RE: **Supplemental Information Request for Application No. 1523635 (the Application)
Kai Kos Dehseh Project – Athabasca Oil Sands Area**

**APPLICATION FOR APPROVAL OF
KAI KOS DEHSEH PROJECT
SUPPLEMENTAL INFORMATION REQUEST ROUND 1**

MATERIAL BALANCE			
BITUMEN PRODUCTION 3180 m3/d (20,000 bpd)			
SOR = 3, RR = 10%			
SCALE	SIZE	DRAWING NUMBER	REV
NONE	B	FIGURE 27-1	C

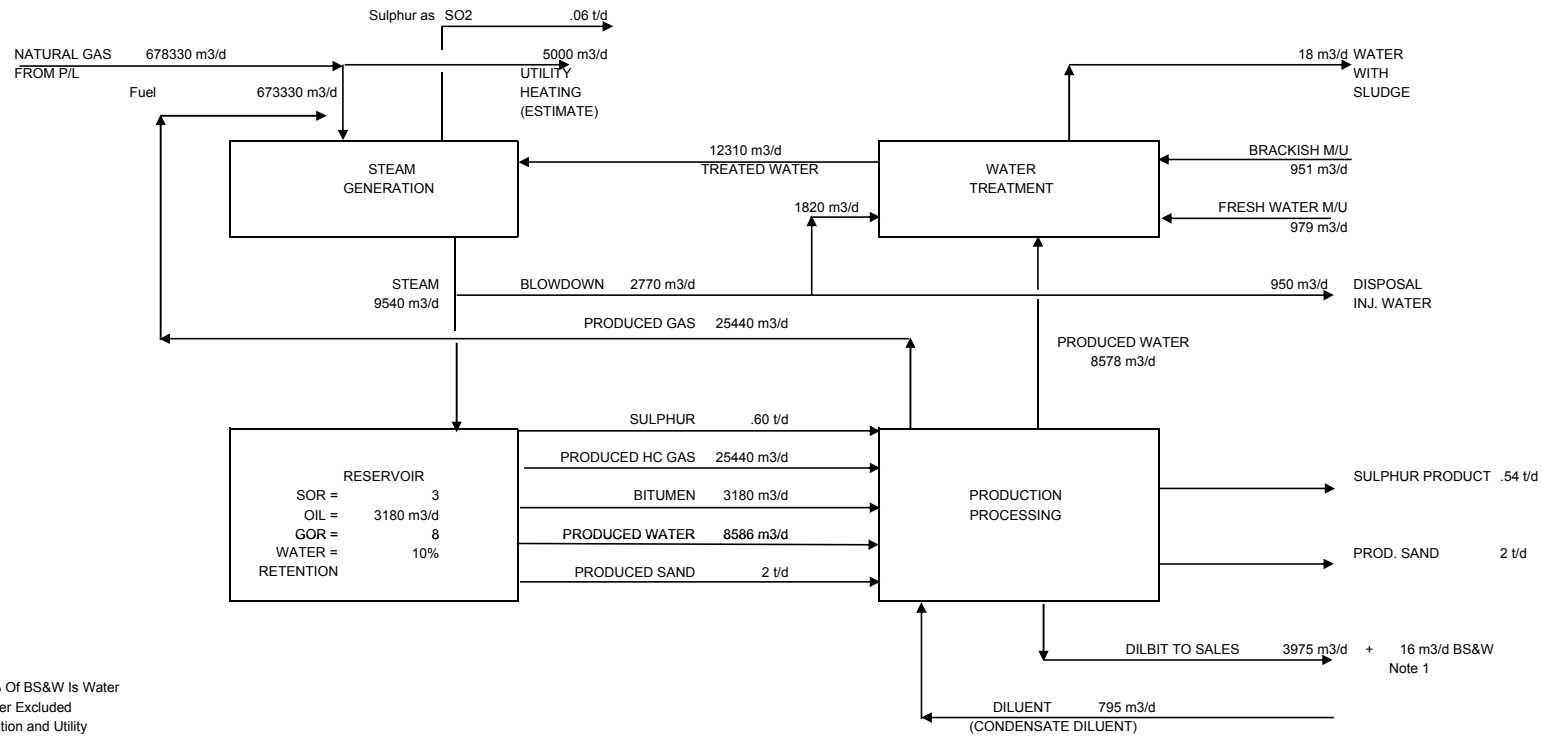
27	<p>Volume 1, Page A-9, Figure A2.2-2. Material Balance. This Figure shows a diluent usage of 795m³/d, which equates to a 20% blend volume.</p> <p>a. Confirm that Statoil Hydro will be able to meet pipeline specifications using this volume of diluent.</p>
----	--

StatoilHydro confirms that it will be able to meet pipeline specifications at all times. The diluent blend ratio required to meet the pipeline specifications depends on the diluent composition, bitumen composition, pressure and temperature conditions and pipeline specifications. If required, trim blending will be performed. See Figure 27-1 (Figure A2.2-2 Revised)

SIMPLIFIED WATER BALANCE FLOW DIAGRAM			
BITUMEN PRODUCTION 3180 m3/d (20,000 bpd)			
- CONTINUOUS PLANT OPERATIONS			
AFTER STARTUP (RECYCLE OPERATING)			
SCALE	SIZE	DRAWING NUMBER	REV
NONE	B	FIGURE 28-1	B

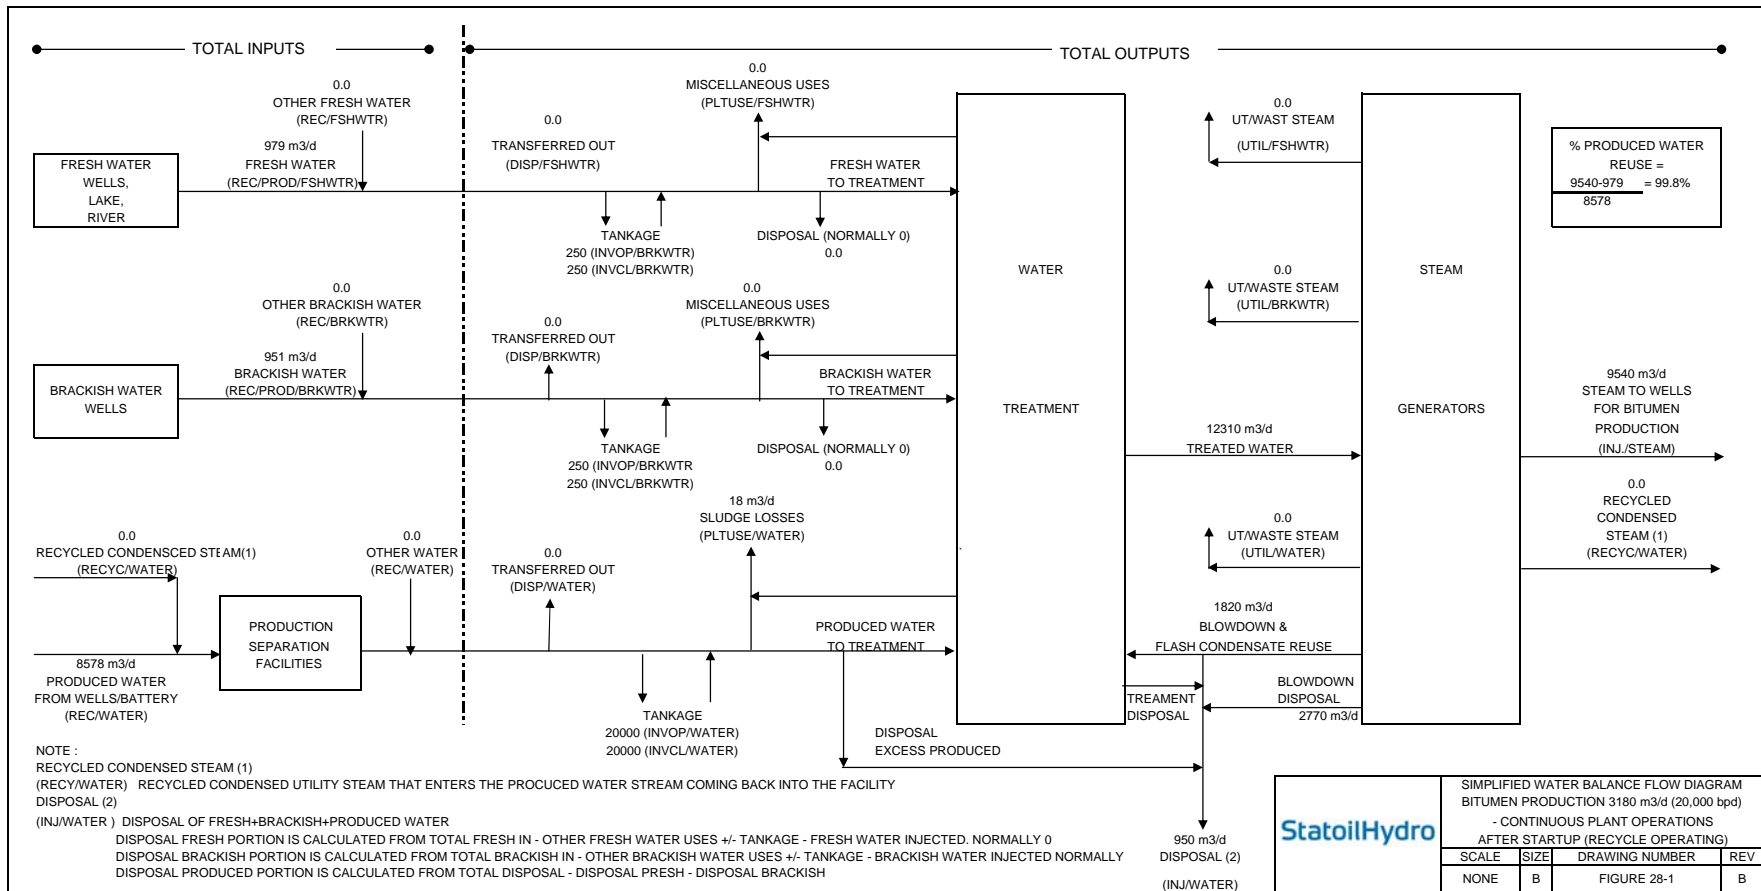
28	<p>Volume 1, Page A-10, Figure A2.2-3, Simplified Water Balance. This Figure shows that no saline water inventory will be kept on site. Page A-7, Section A2.2 states that one saline water tank is to be added to the facility.</p> <p>a. Clarify whether saline water inventory will be kept on site and if so, adjust the Figure accordingly.</p>
----	---

Saline water inventory will be kept on site and the water balance is adjusted to reflect this. See Figure 28-1 (Figure A2.2-3 Revised).

Figure 32-1 Interfingered Pad Layout Design

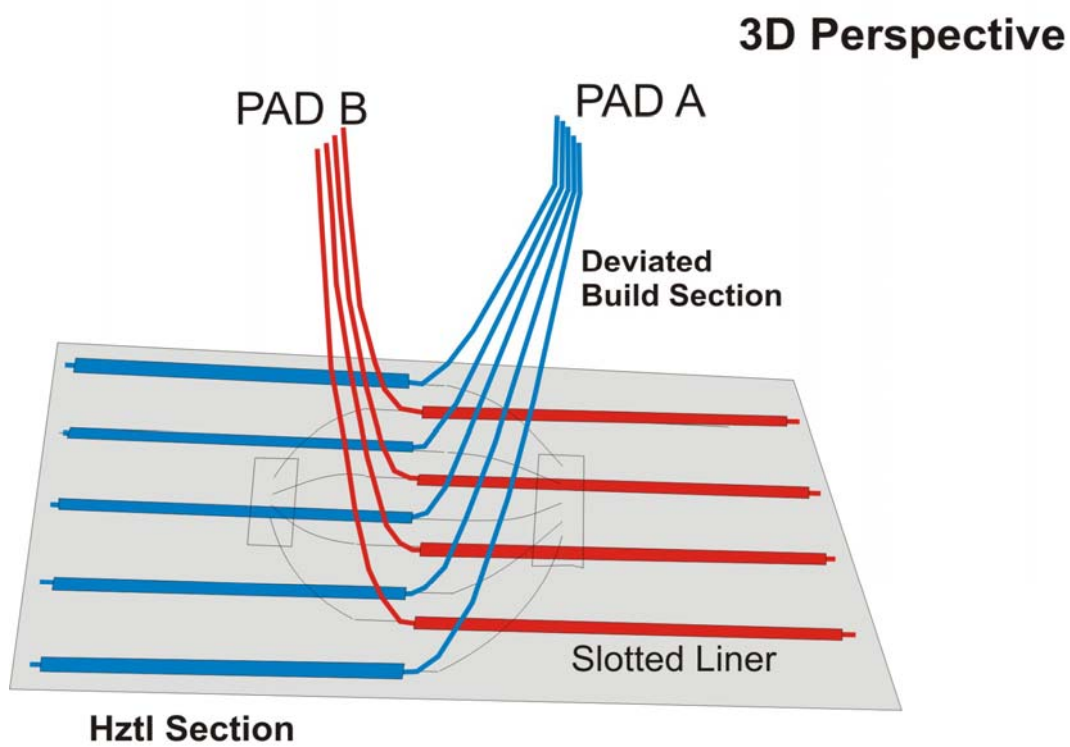
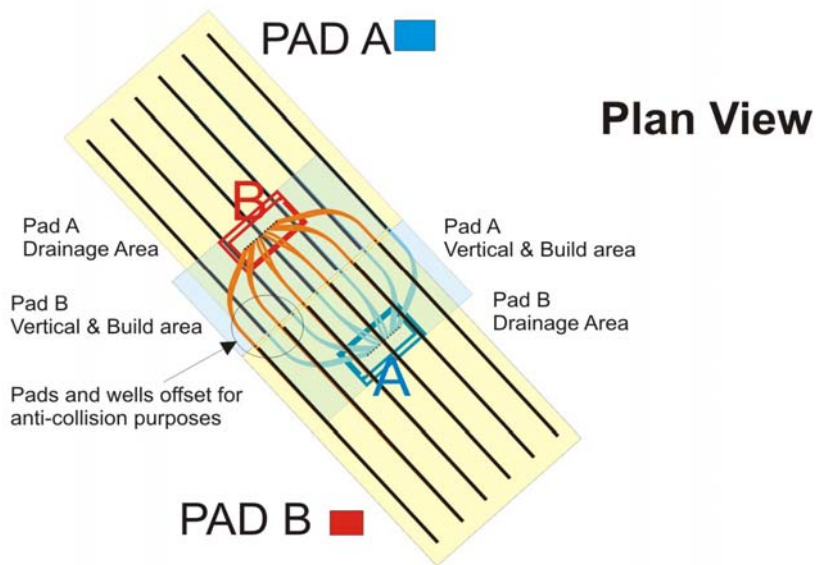
Volume 1, Page B-58, Figure B4.1-8, Well Placement. The Figure appears to show wells with concentrated spacing for the first third of the well on four of the proposed pads.
a. Comment on the rationale for this reduced spacing and well placements.

There is no concentrated or reduced spacing. Interfingered well pads, Figure 32-1, have been positioned facing each other with the pads and well bores offset to minimize the chance of well bore collision while drilling. Similarly configured existing pads can be found at MEG Hardy (16-077-05W4M), Devon Jackfish (32-075-06W4M) and Nexen Opti Long Lake (30-085-06W4M.) As shown, it is the build sections that are overlapping not the horizontal sections.

MATERIAL BALANCE			
BITUMEN PRODUCTION 34980 m3/d (220,000 bpd)			
SOR = 3, RR = 10%			
SCALE	SIZE	DRAWING NUMBER	REV
NONE	B	FIGURE 39-1	C

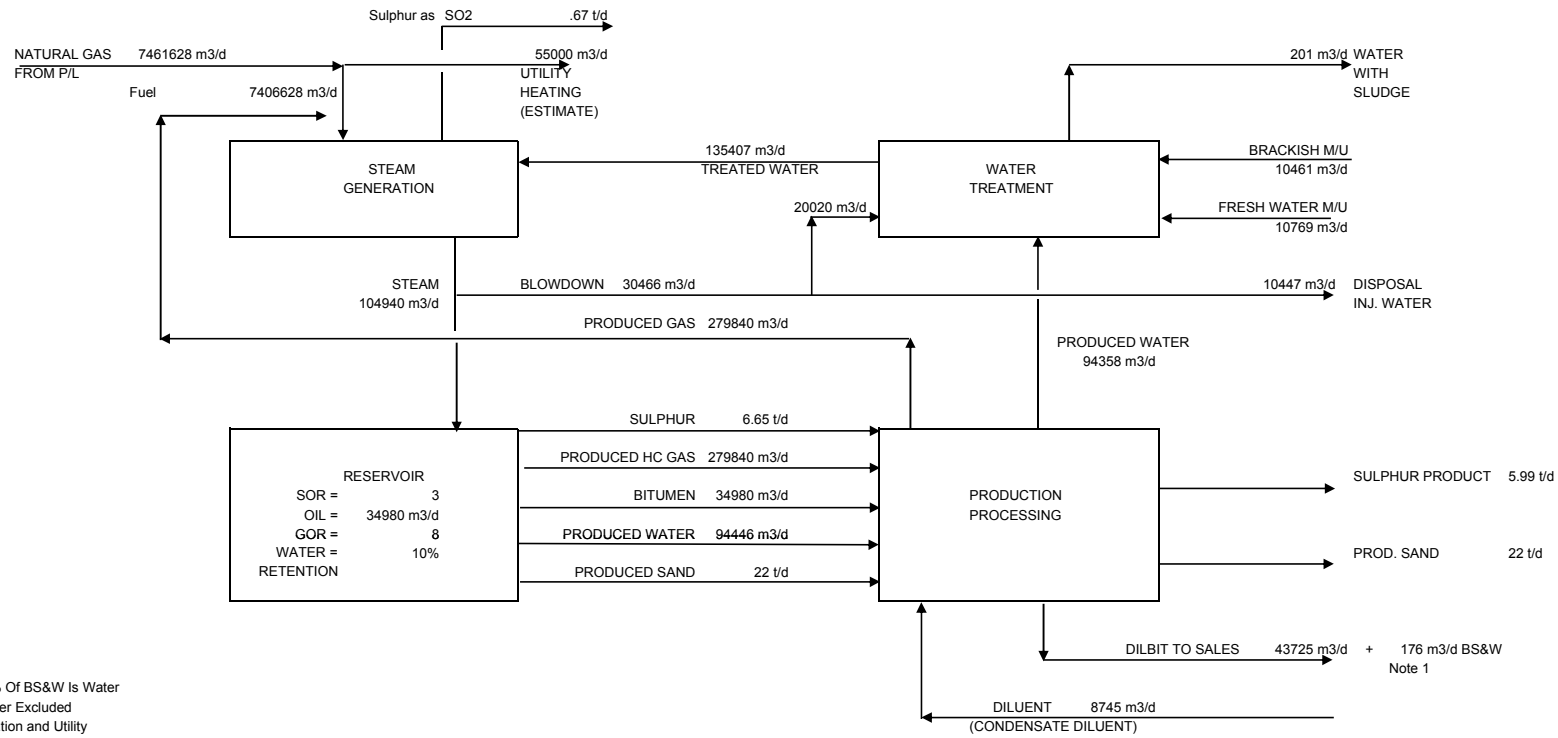
39	<p>Volume 1, Page 114, Figure 5.2-8, Material Balance. This Figure shows that a volume of 69 960m³/d diluent is to be used for separation and blending with an associated bitumen projection volume of 34 980m³/d.</p> <p>a. Clarify the apparent discrepancy.</p>
----	---

The volume of 69,960 m³/d is indeed incorrect. For a bitumen rate of 34,980 m³/d the correct diluent volume rate is 8,745 m³/d. See Figure 39-1 (Figure 5.2.-8 Revised).

SIMPLIFIED WATER BALANCE FLOW DIAGRAM			
				BITUMEN PRODUCTION 34980 m3/d (220,000 bpd)			
				- CONTINUOUS PLANT OPERATIONS			
				AFTER STARTUP (RECYCLE OPERATING)			
SCALE	SIZE	DRAWING NUMBER	REV				
NONE	B	FIGURE 40-1	B

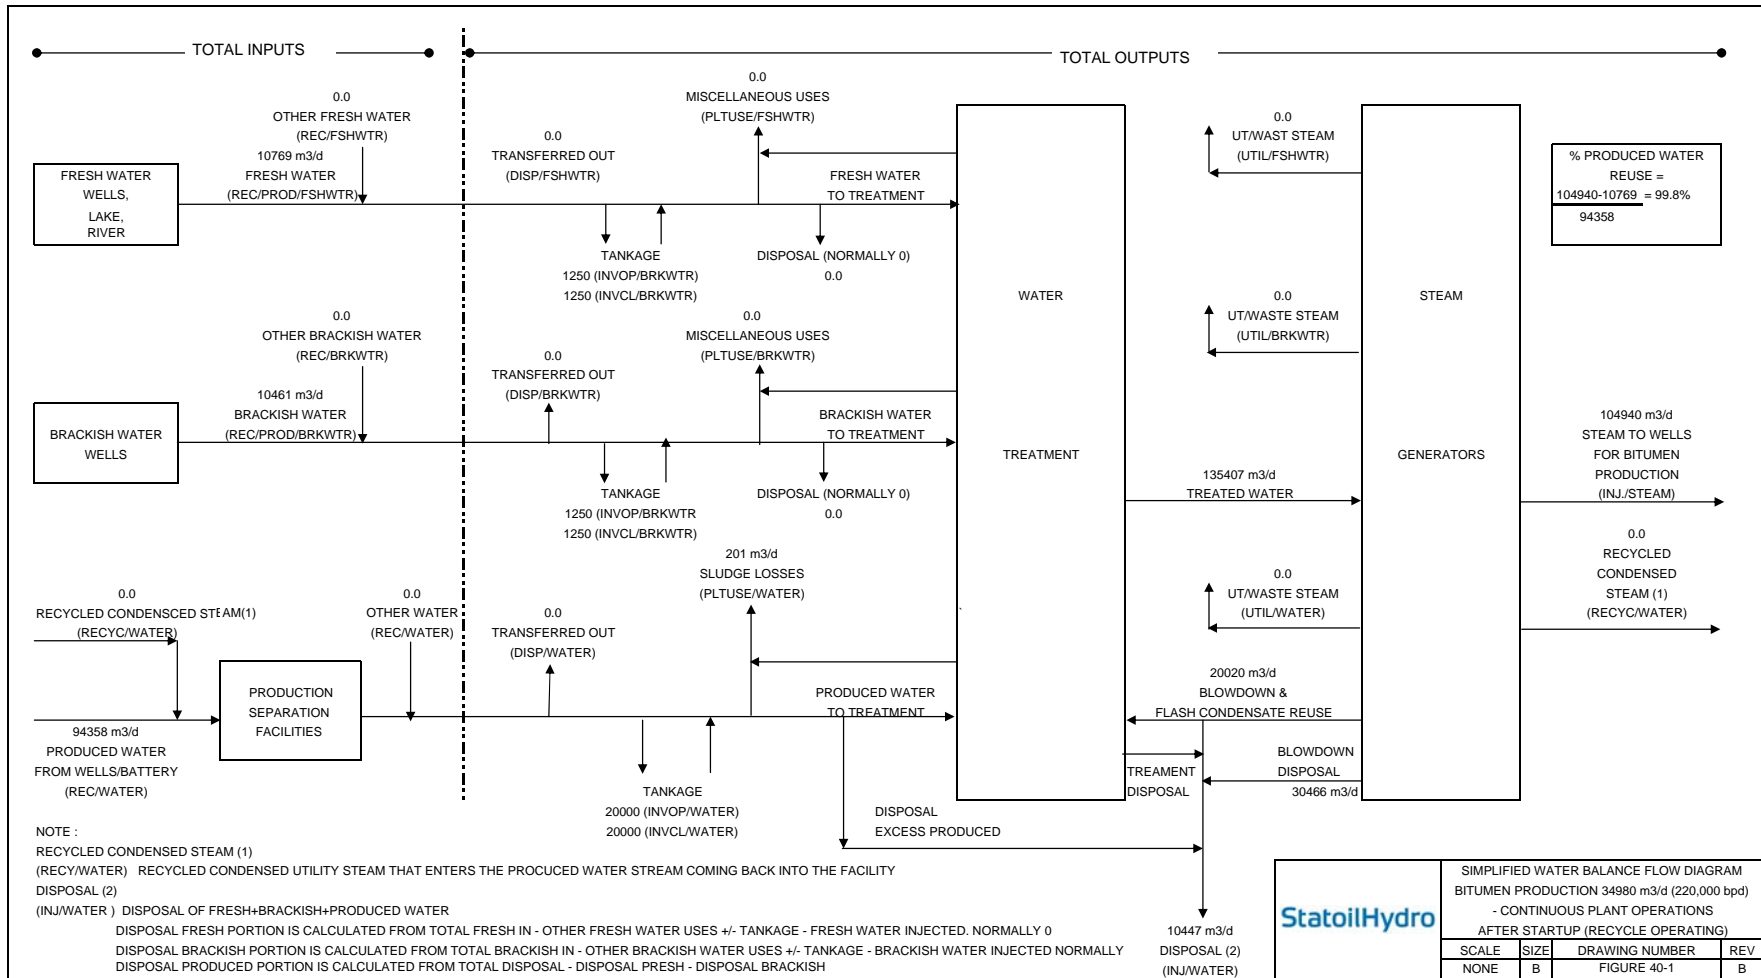
40	<p>Volume 1, Page 114, Figure 5.2-8, Material Balance. The notes associated with this Figure assume 50% water content in the sediment and water component. Assessment of this Figure shows that balance is achieved when 100% S&W water content is utilized.</p> <p>a. Clarify the composition of the S&W.</p>
----	---

The balance did assume a 100% water content in the BS&W. This was in error to the note that states, "Assumes 50% of BS&W is Water". The composition of Basic Sediment & Water shall be 50% water. The material balance sheet has been modified to reflect the same. See Figure 39-1 and 40-1 (Figure 5.2-9 Revised).
